Inspection Photos

Loc: 485760

Operator: WAVETECH HELIUM INC

Inspection Date: 2/26/2025

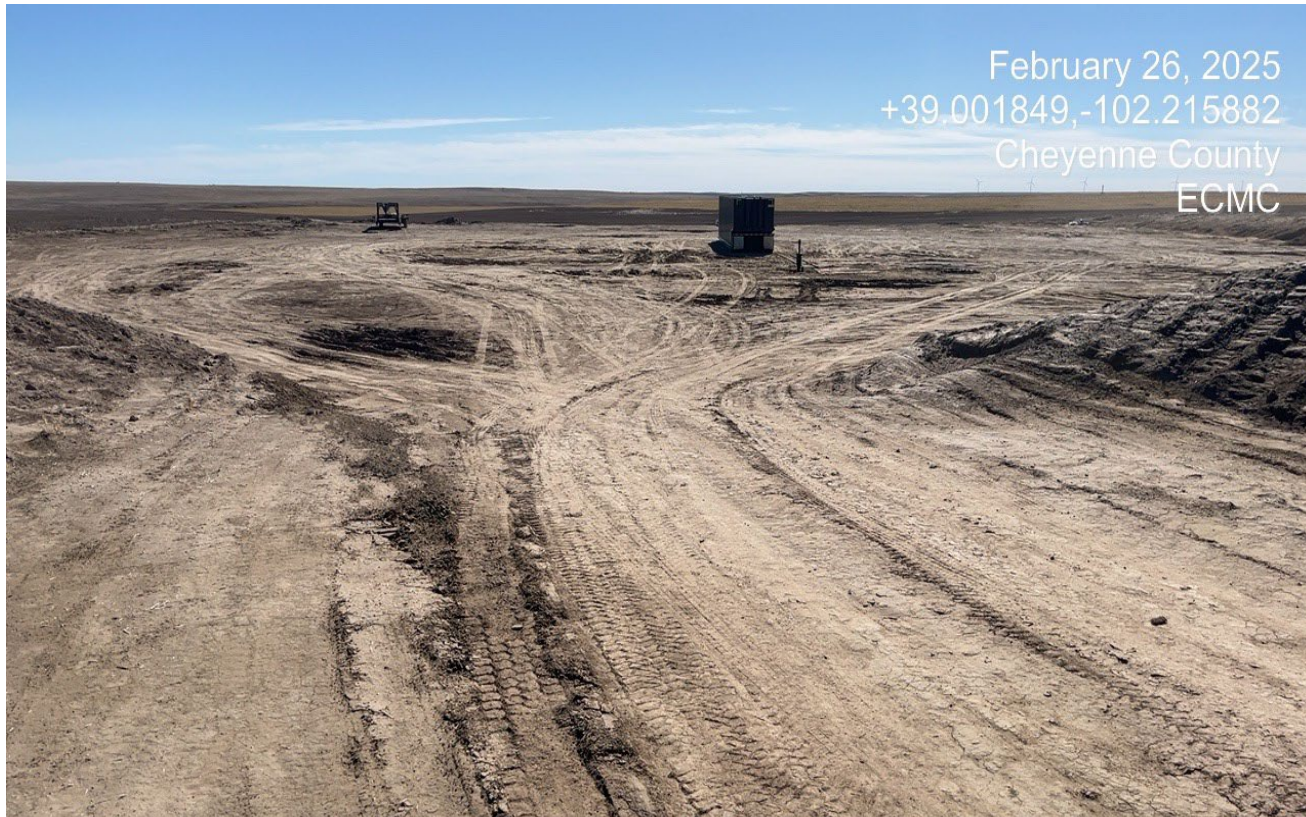
Photo 1. Facing south along the access road. The access road needs to be reduced in size by reclaiming and decompacting soils.

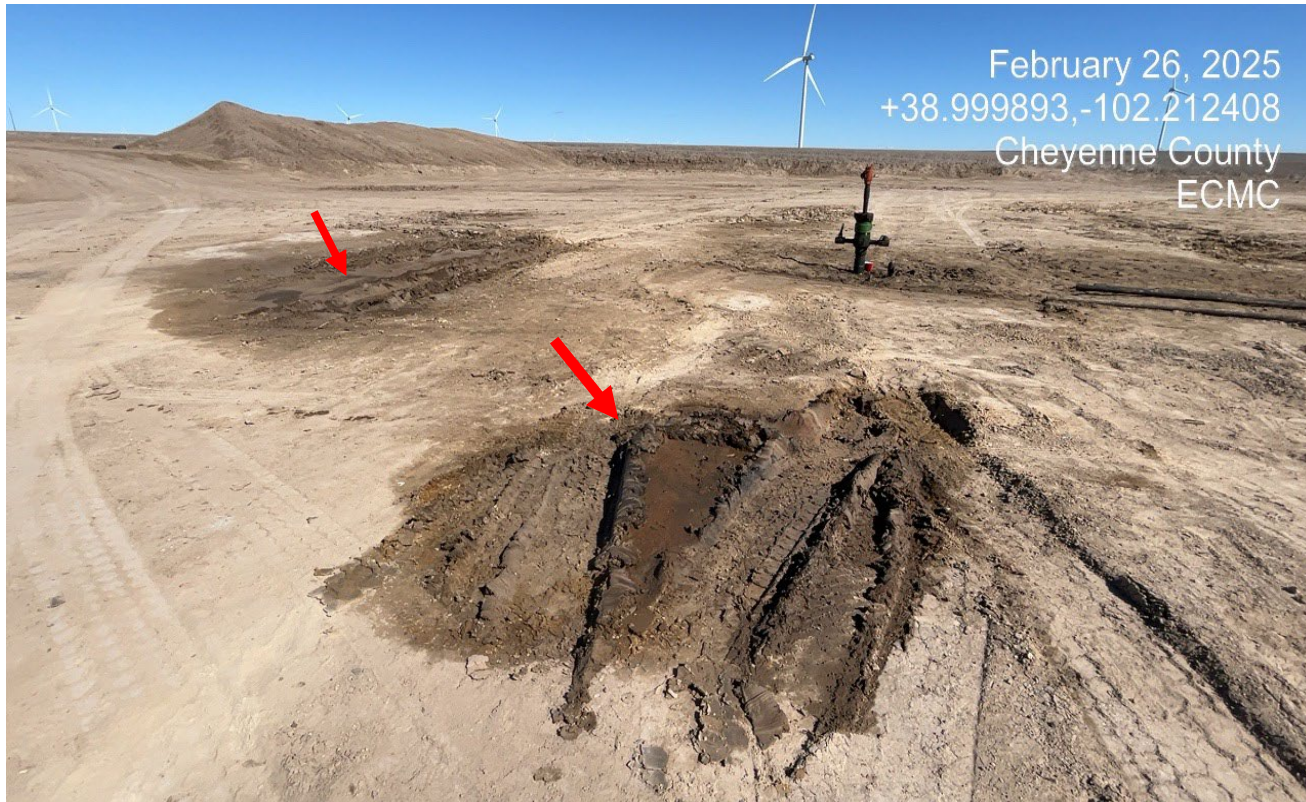
Photo 4. Facing toward the northeast side of the location. There is erosion along the topsoil pile which is mixing soil into the pad surface and subsoils. The topsoil is not stabilized or protected.

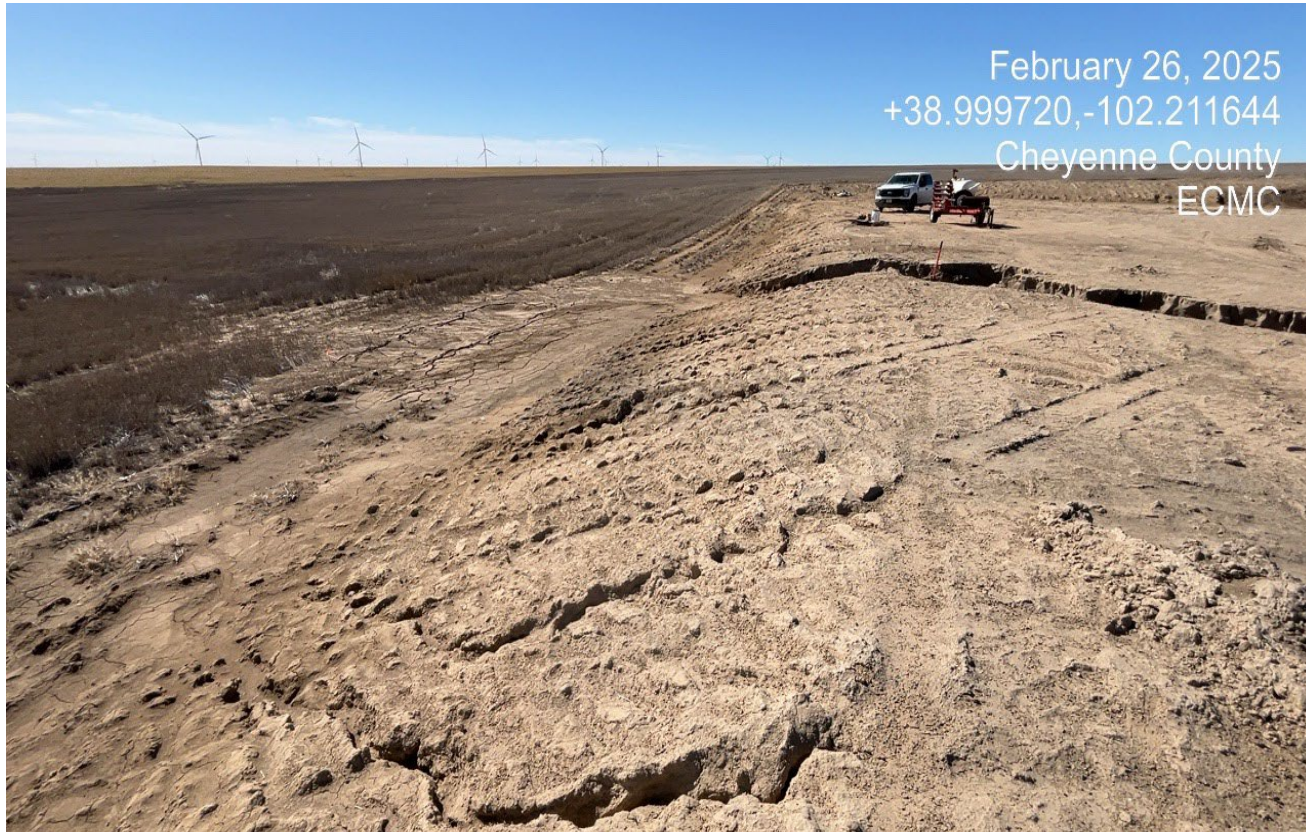
Photo 7. There is significant gully erosion along the fill slope which has washed sediment out into the adjacent crop field. Red arrow points to 4.5 ft. shovel. Previous CA was not completed.
